Modification of Development Consent

Section 4.55(1A) of the *Environmental Planning and Assessment Act 1979*

Development consent:	Consent DA 165-7-2005 granted by the then Minister for Planning on 14 February 2006
For the following:	Haerses Road Quarry
Applicant:	Dixon Sand (Penrith) Pty Ltd.
Consent Authority:	Minister for Planning
The Land:	Lot 170 DP 664766 Lot 170 DP 664767 Lots A and B DP 407341 Lots 176 and 177 DP 752039 Haerses Road Intersection of Wisemans Ferry Road and Haerses Road
Modification:	Modification 5

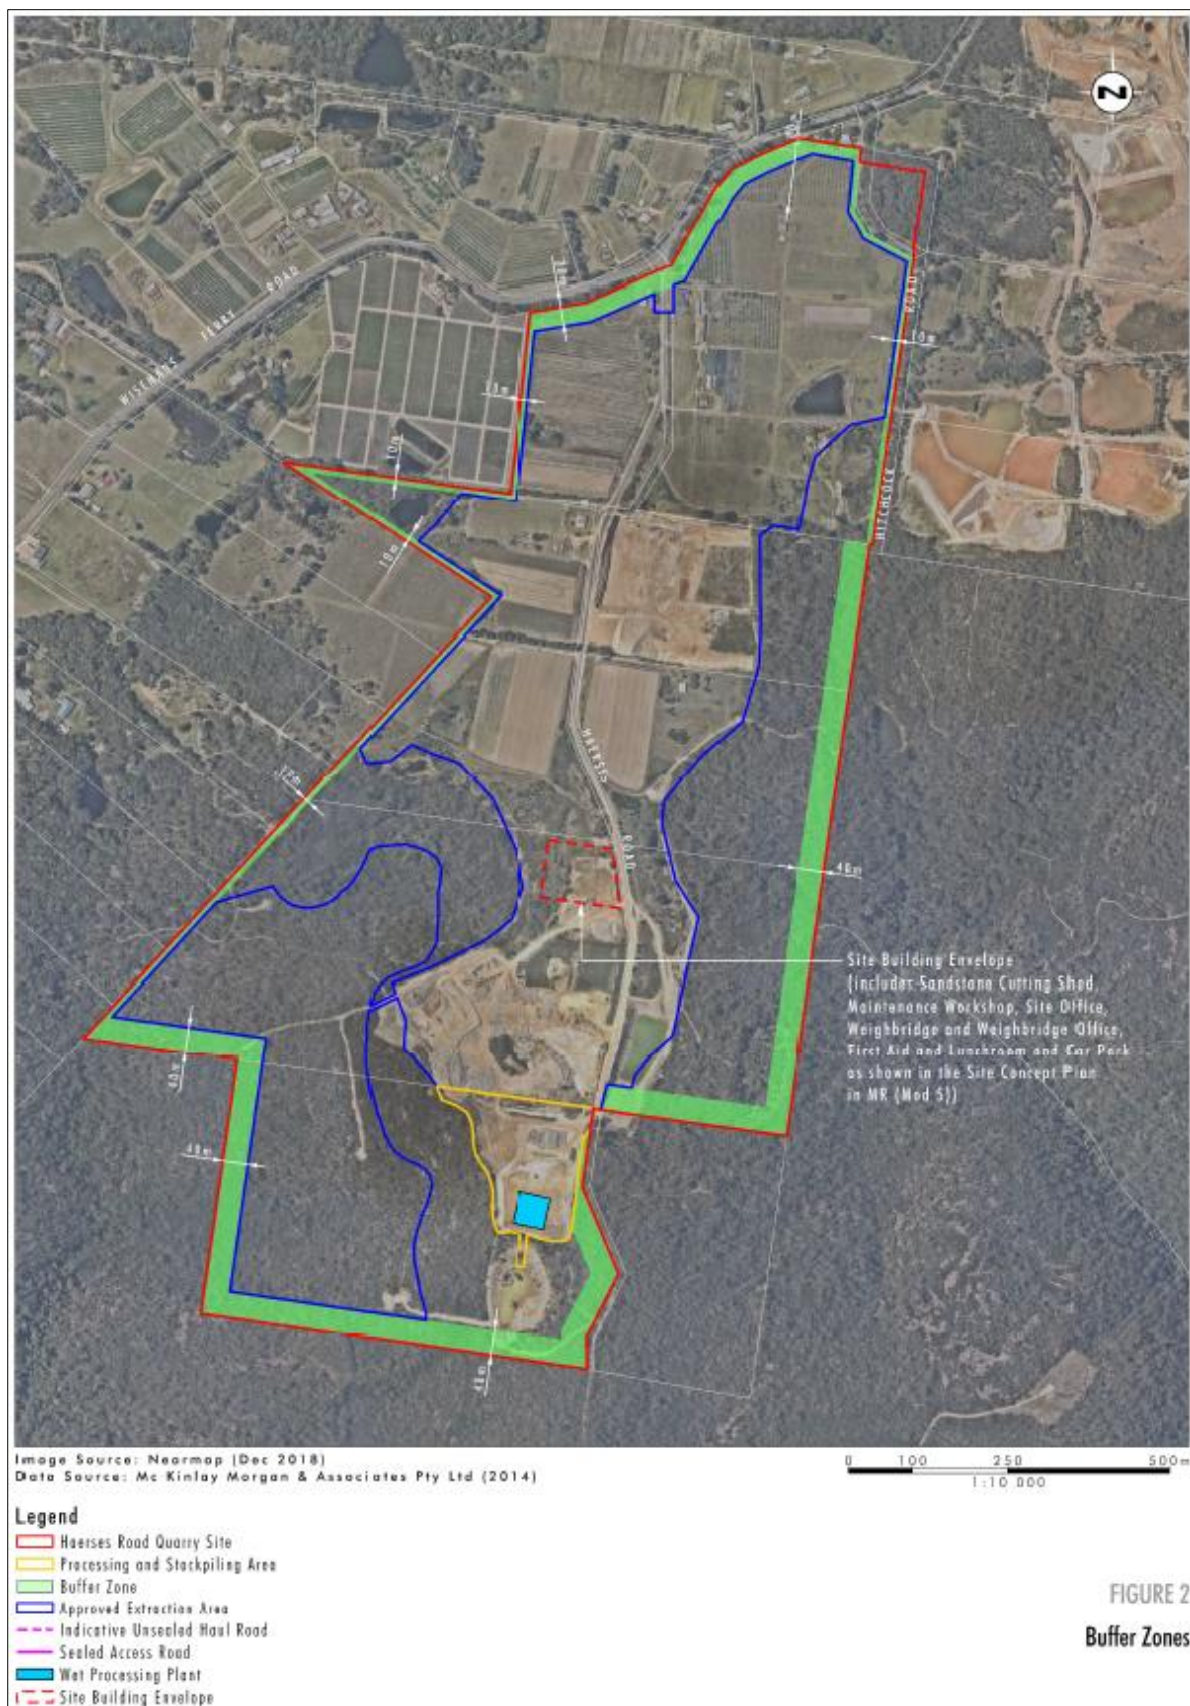
11. In Appendix 1, delete Figure 1 and insert the following figure:

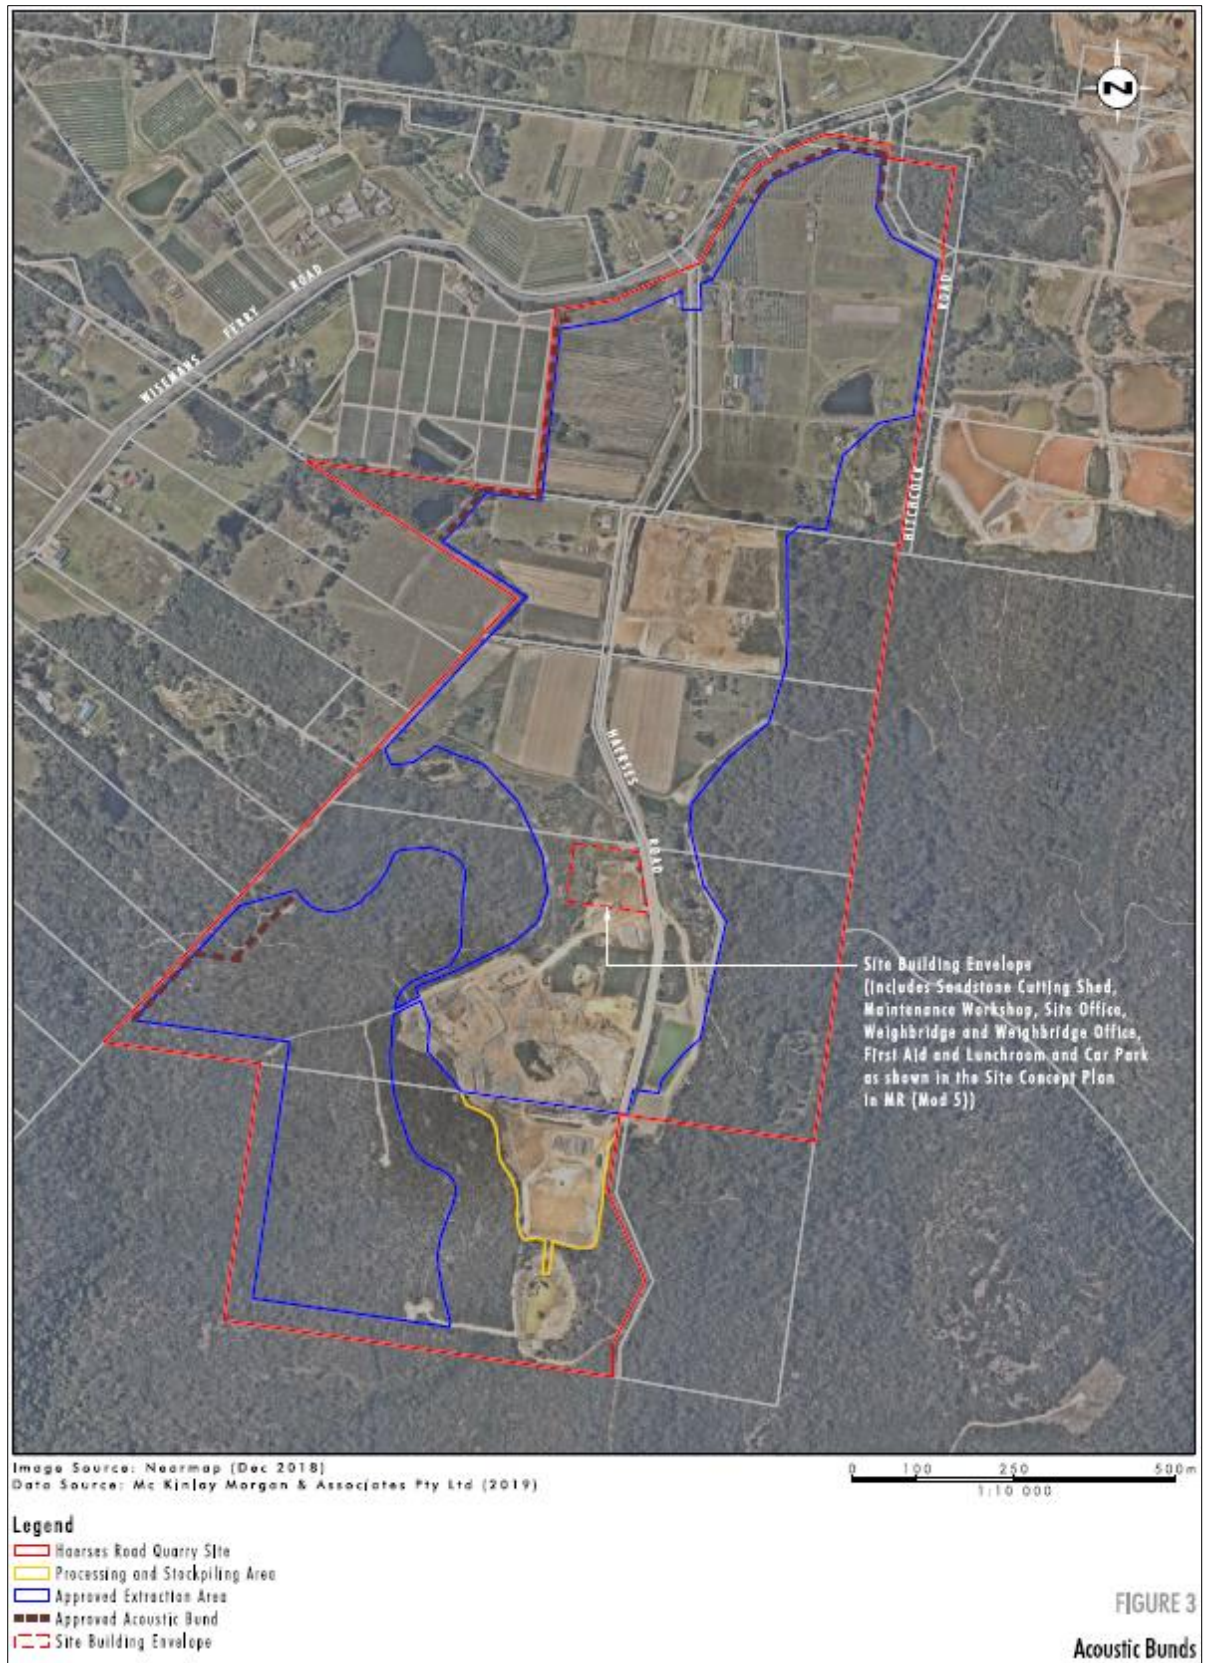
12. In Appendix 2, delete the figure and insert the following figure:

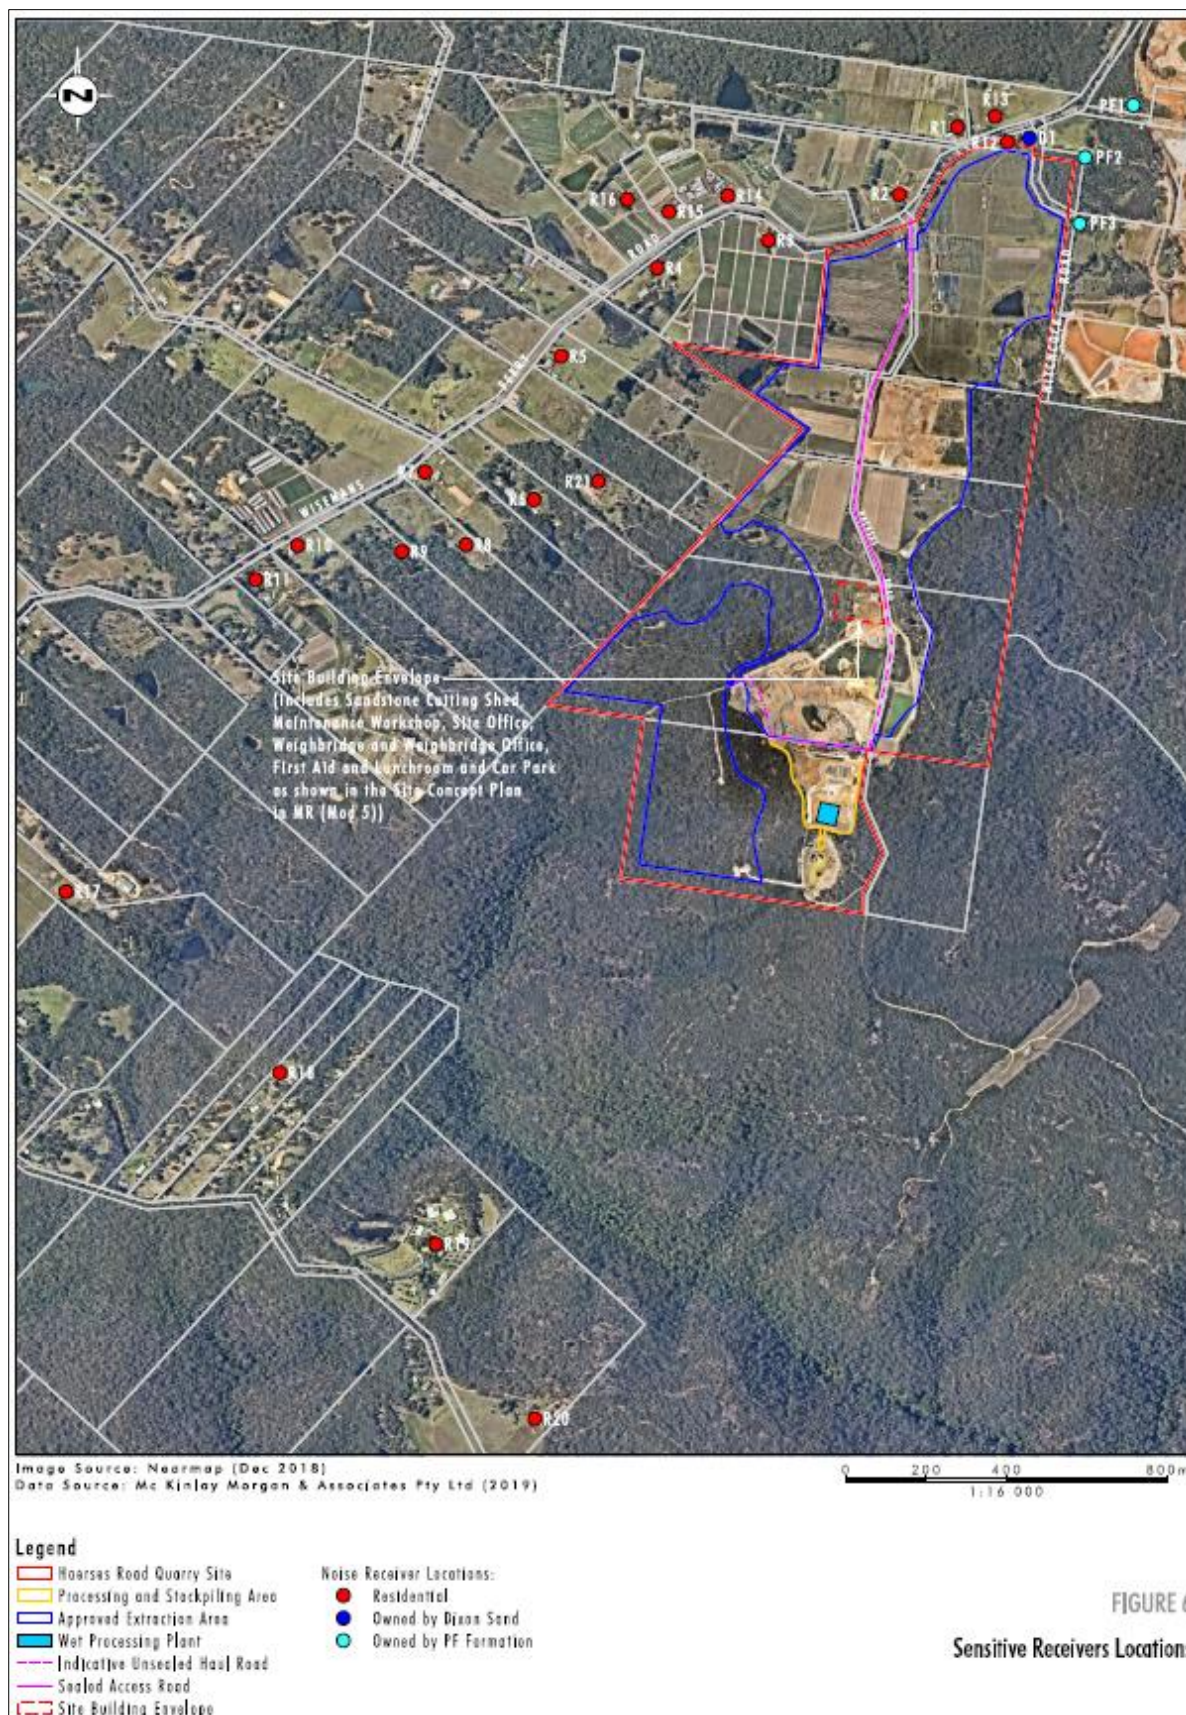
14. In Appendix 4, delete Figure 2 and insert the following figure:
